THE MARYLAND-NATIONAL CAPITAL PARK AND PLANNING COMMISSION

REVIEW TYPE: Pre-Preliminary Plan Review (**Advisory Only**)

PROJECT NAME: Hillmead/Bradley Hills

CASE #: 7-05051

PRELIMINARY PLAN
 A REVISION OF PART OF LOTS 1, 7 & 8, BLOCK 1
HILLMEAD/BRADLEY HILLS
 THE ELECTION DISTRICT OF MONTGOMERY COUNTY, MD.
 BY MAP ON 153 WSSC NO 21021102

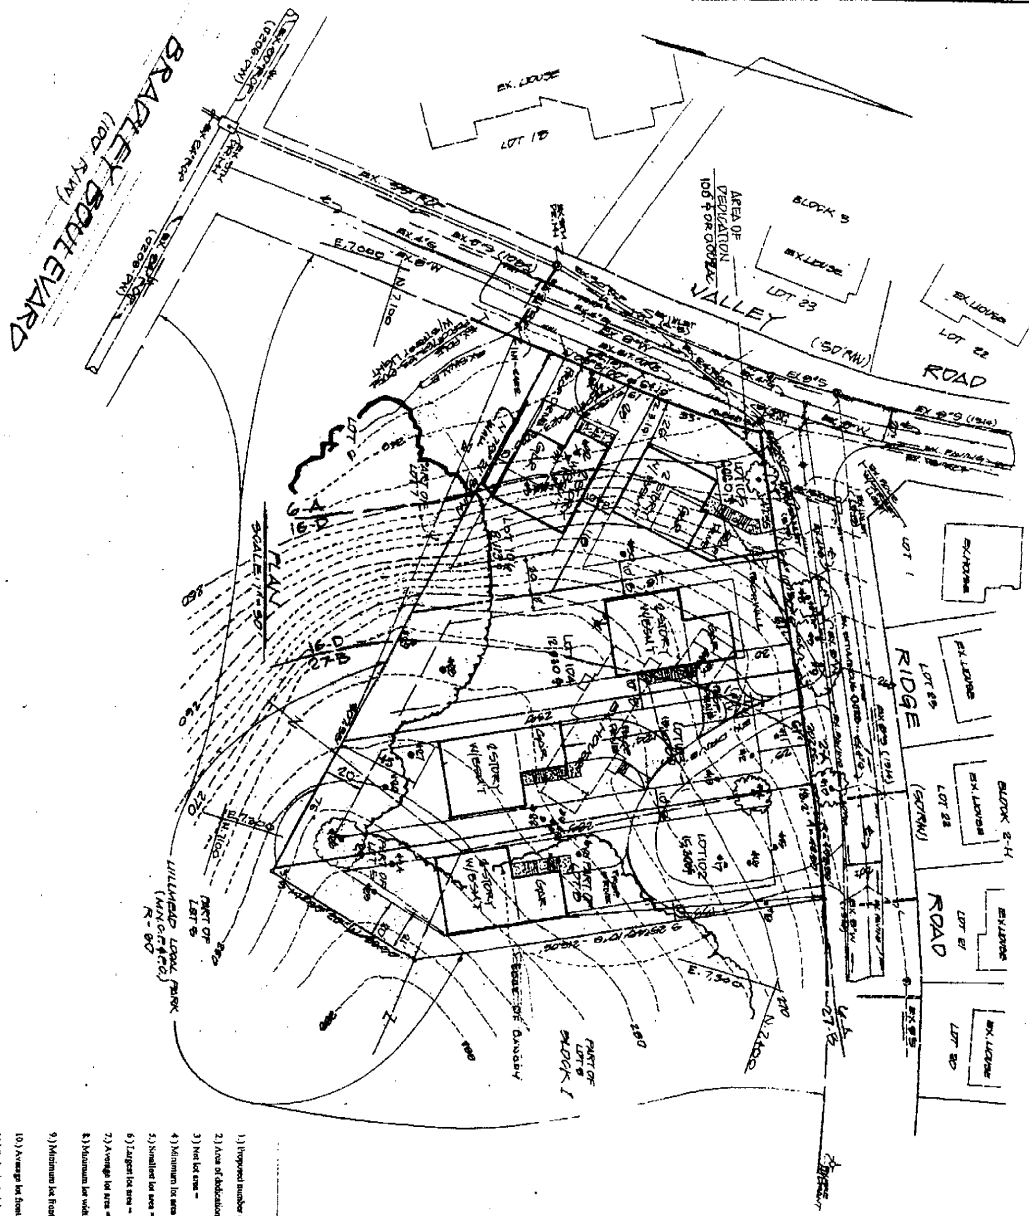
Suitability for Residential Use: Staff believes that the suitability of proposed lot 105 is compromised due to the configuration of its useable area. While the gross square footage of the useable area of Lot 105 compares favorably with all lots in the defined neighborhood, the shape of the building envelope dictates a house location that leaves little useable rear or side yard for outdoor activities. The lot is a corner lot, and as such, it essentially has two front yard setbacks, at 25 feet from the street frontage. The front yard setback, as required in the R-60 zone, greatly shrinks the useable area for this lot and is further compounded by the shape of the lot that tapers to the rear. Although not required under the Zoning Ordinance or Subdivision Regulations it has been staff practice to attempt to require at least 25 feet from the rear of the house to the closest lot line. This enables adequate area for recreation, decks, sheds, or modest additions within the rear yard.

Lot 105 on the proposed plan is very tight, with the apparent rear of the house up against the 8 ft. side yard setback. A small triangular area of approximately 1,000 square feet to the side of the proposed house is the only private yard area available for outdoor recreation. Only 700 square feet of the 1,000 square feet is within the building envelope to allow for an addition if it were ever proposed. While the distance from the side of the house to the nearest lot line exceeds 25 feet in places, it is, in staff's estimation, inadequate. Therefore, staff does not believe that proposed Lot 105 is suitable for residential development.

Staff believes that proposed Lots 105 and 106 are out of character with respect to the larger, wider lots directly across the street on Valley Road. Staff does not support the proposal to create two lots with a combined frontage width (118 ft.) on Valley Road that is less than the width of the single lot (Lot 23, Block 3) immediately across the street (148 ft.). The proposal also creates a 4:3 relationship of proposed lots to existing lots on the Ridge Road frontage that Staff does not support.

Staff does not support the creation of Lots 105 and 106 with respect to size, as they are out of character with the large lot nature of Lots 22 and 23, Block 3, immediately across Valley Road. Lots 22 and 23, Block 3, are 22,506 square feet and 19,623 square feet, respectively. The proposed Lots 105 and 106 are 6,660 and 8,113 square feet, respectively, or less than half the size of the two lots across the street. To Staff, the relationship appears to be very much out of character given their location in the subdivision.

with all seven criteria, specifically, staff believes that Lot 105 as shown on the submitted pre-preliminary plan is not suitable for residential use in that there is insufficient private outdoor area to the rear (or side) of the proposed home. In keeping with staff practice we would not support a lot with such limited useable yard.

Additionally, Section 50-29(a)(1) requires that lots be appropriate for their location within a subdivision with respect to size, shape, width and orientation. Staff does not believe that Lots 105 and 106 are appropriate with respect to size and width. They are not of the same character as the lots immediately confronting on Valley Road as they create a 4:3 relationship and are less than half the size of the existing lots.

For these reasons, Staff objects to the resubdivision of the property into five lots. Staff believes a four lot subdivision, which combines the areas of proposed Lots 105 and 106 as shown on the submitted pre-preliminary plan, may be more appropriate for the site.
